**ESKOM EIA CONCERNS FOR THE PROPOSED NUCLEAR POWER STATION AND ASSOCIATED INFRASTRUCTURE (DEA Ref. No: 12/12/20/944)**

**DYER ISLAND CONSERVATION TRUST: LETTER OF CONCERN ASSOCIATED WITH THE ESTABLISHMENT OF A NUCLEAR POWER STATION AT BANTAMSKLIP**

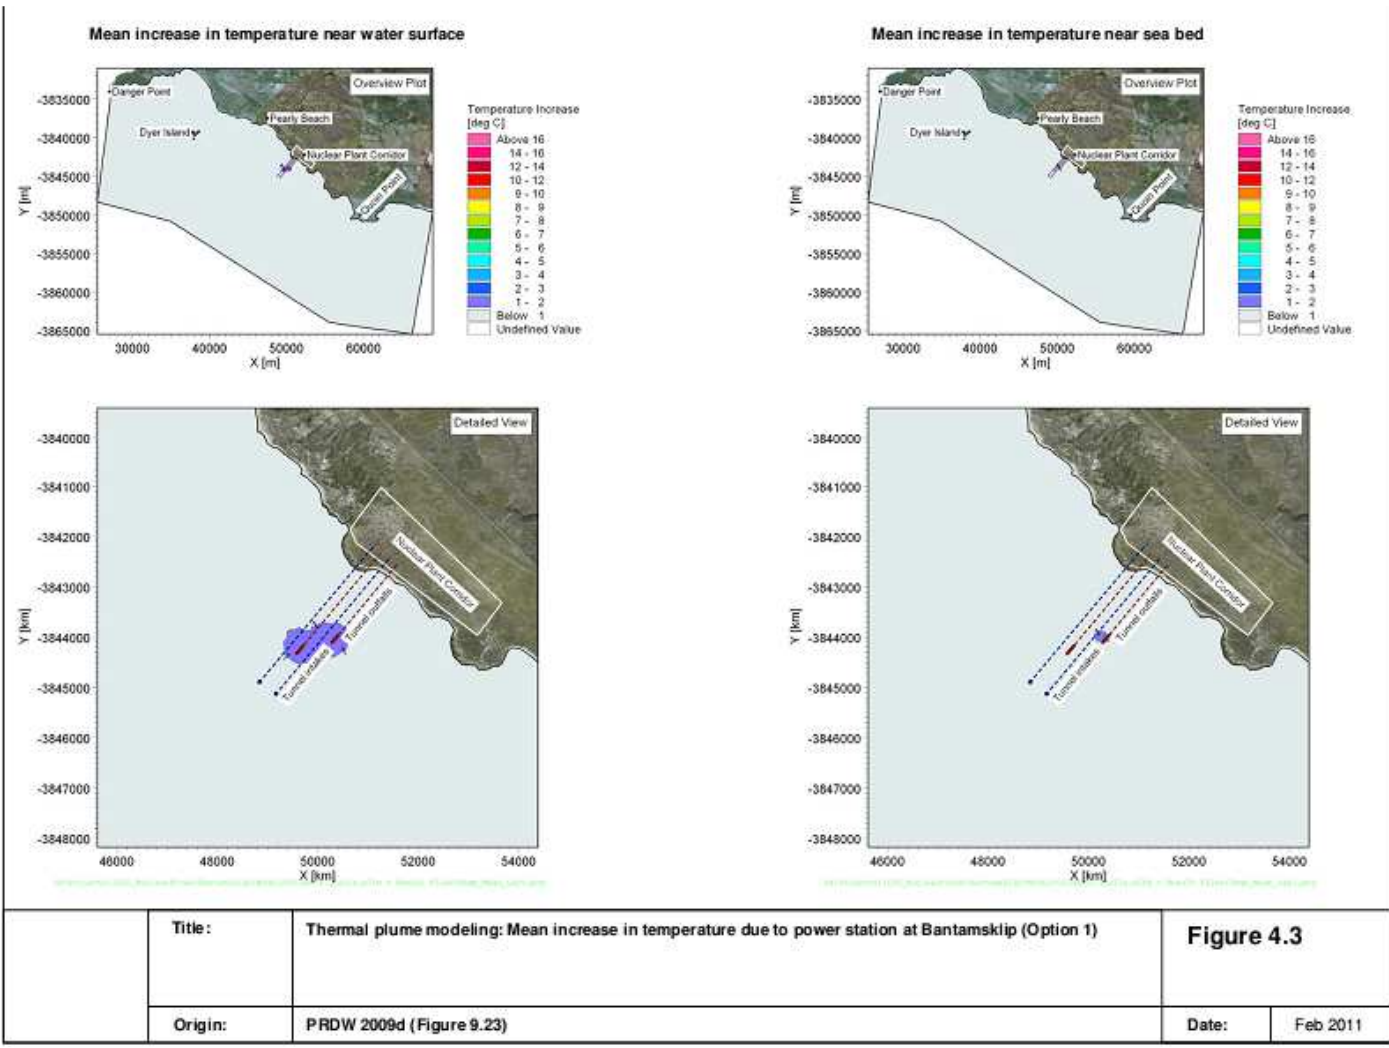
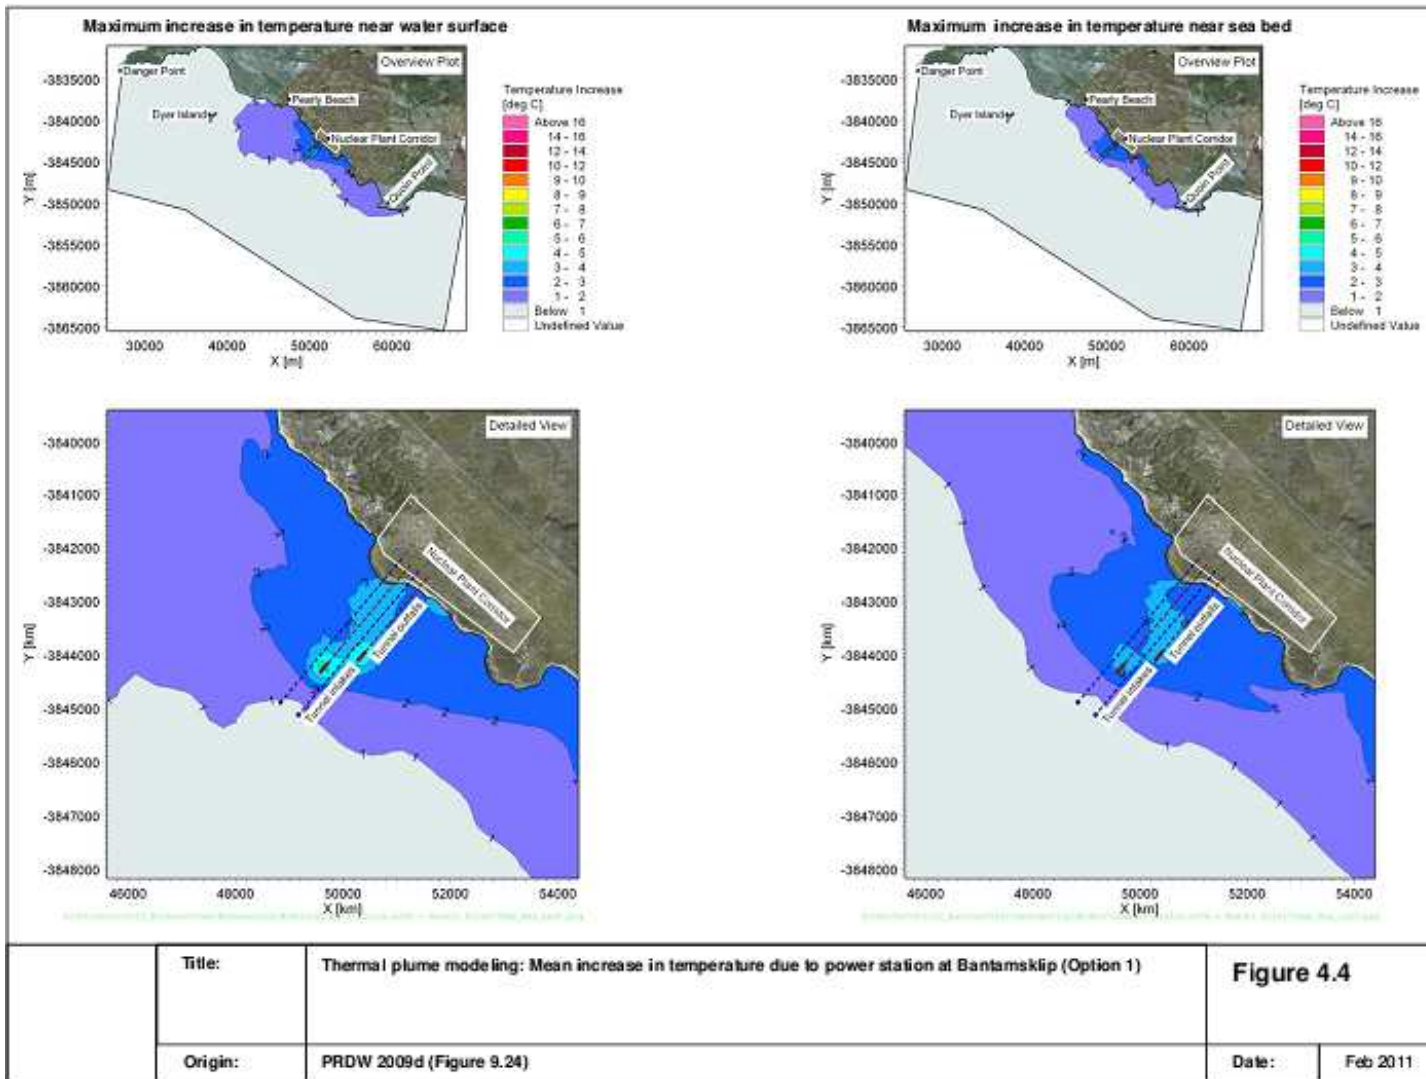
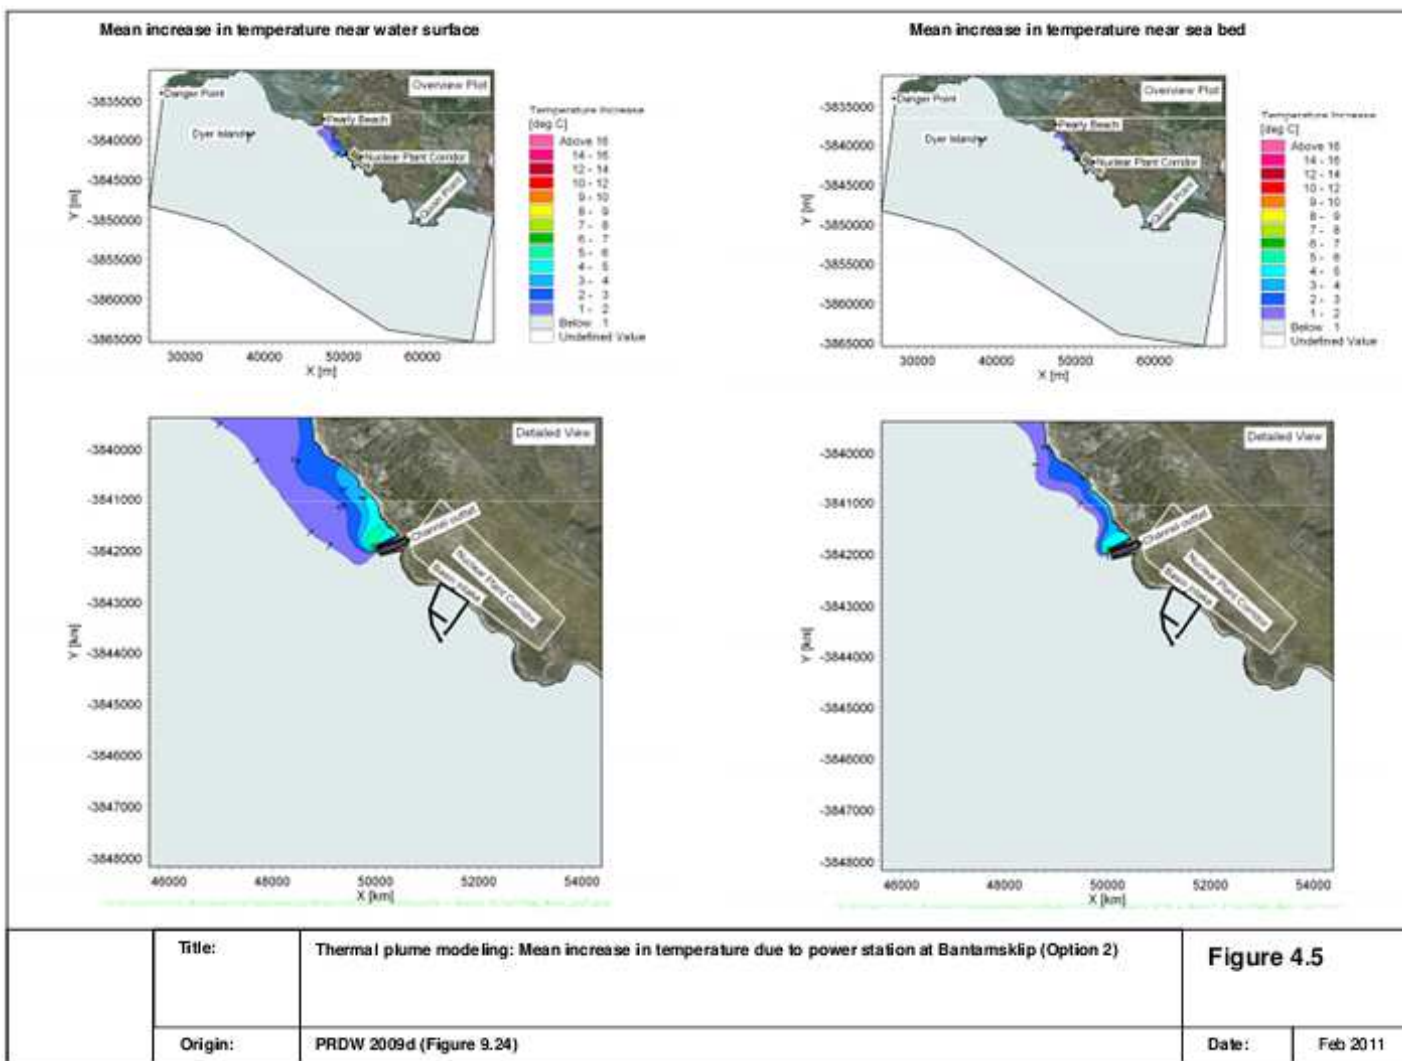
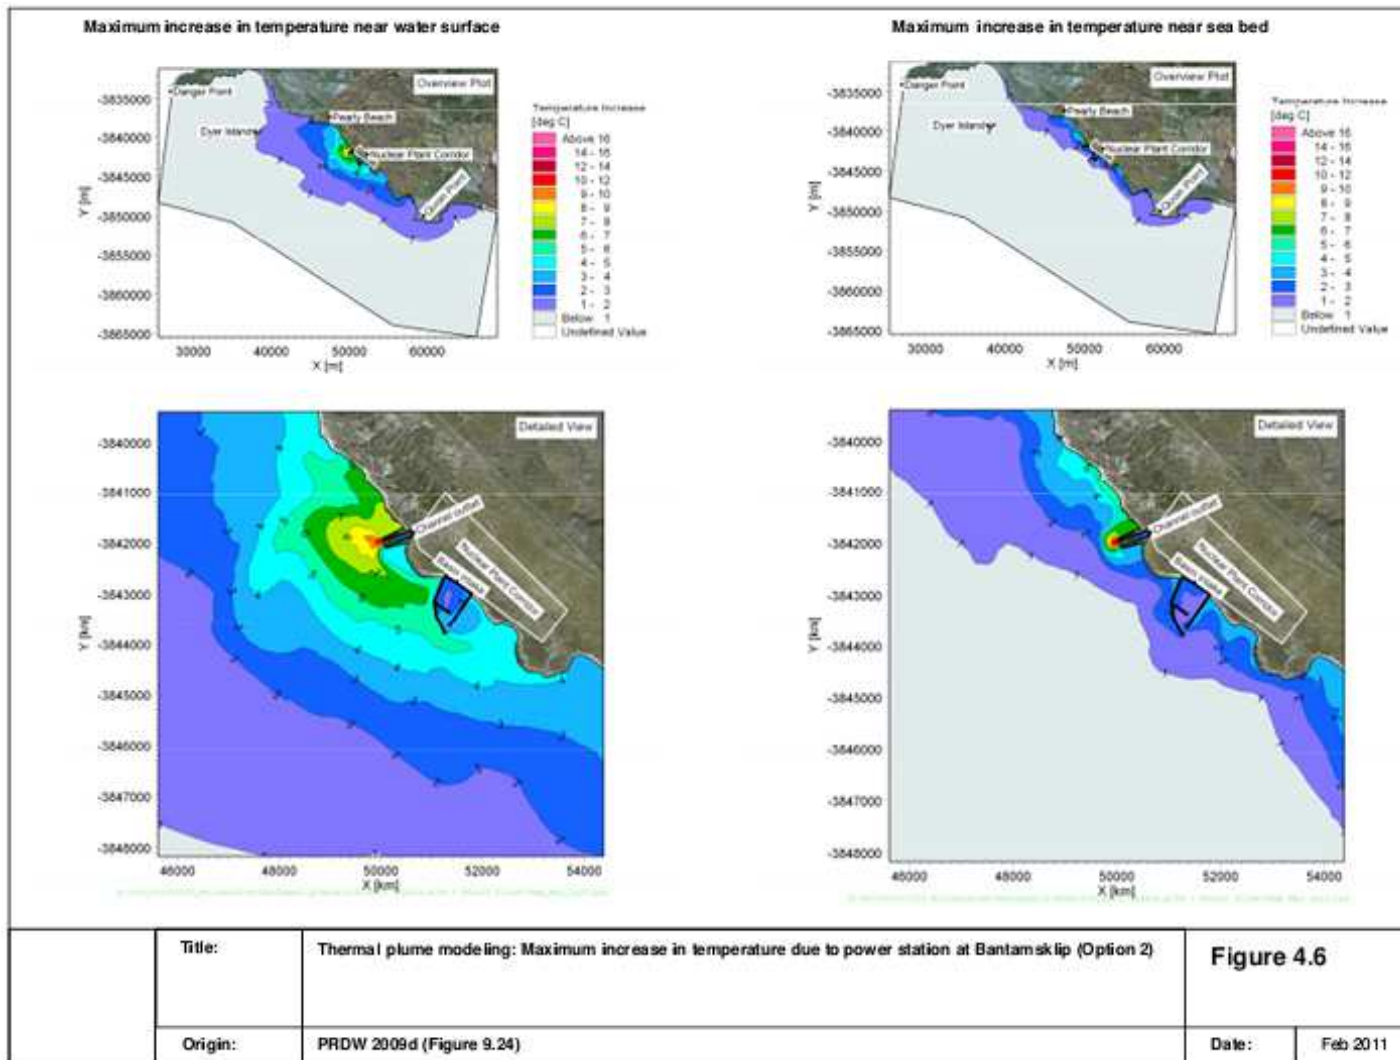
The MEIS does not provide any information about how the spoil will be transported to the off shore position and what the impact of this transportation might be. This information is required to complete the MEIS.

As indicated in the Marine Ecology Assessment (Appendix E15 of the Revised Draft EIR Version 1), two disposal alternatives for spoil are assessed at each of the sites: a nearshore and an offshore disposal option. These alternatives are also discussed in Section 5.12 of the Revised Draft EIR Version 1. Different pumping rates for the spoil are also considered.

It is stated in the Marine Ecology Assessment that the impacts of spoil disposal will be twofold:

- Firstly as a sediment plume within the water column (consisting mainly of fine muds), which may block light penetration and filtering apparatus of filter feeders; and
- Secondly as a layer covering the sea bottom (consisting mainly of coarser sands) that will bury the current benthic environment and biota.

Impacts of the spoil disposal alternatives in terms of the movement of the spoil over time are assessed in Appendix I of the Oceanographic Assessment (Appendix E16 of the Revised Draft EIR Version 1). The assessment of impacts in the Marine Ecology Assessment is based on the spoil movement patterns modeled in the oceanographic assessment. Section 3.2.1 of the Marine Ecology Assessment states that "*Alternatives 4, 5 and 6 (i.e. either the full or half the volume of spoil disposed offshore at either a medium or high flow rate) are considered preferable*". Based on these alternatives, the total length of time over which disposal will occur could be 29 days (at a pumping rate of 3.93m<sup>3</sup>/s) or 56 days (at a pumping rate of 2.06m<sup>3</sup>/s) if pumping takes place without interruption, 24 hours per day.
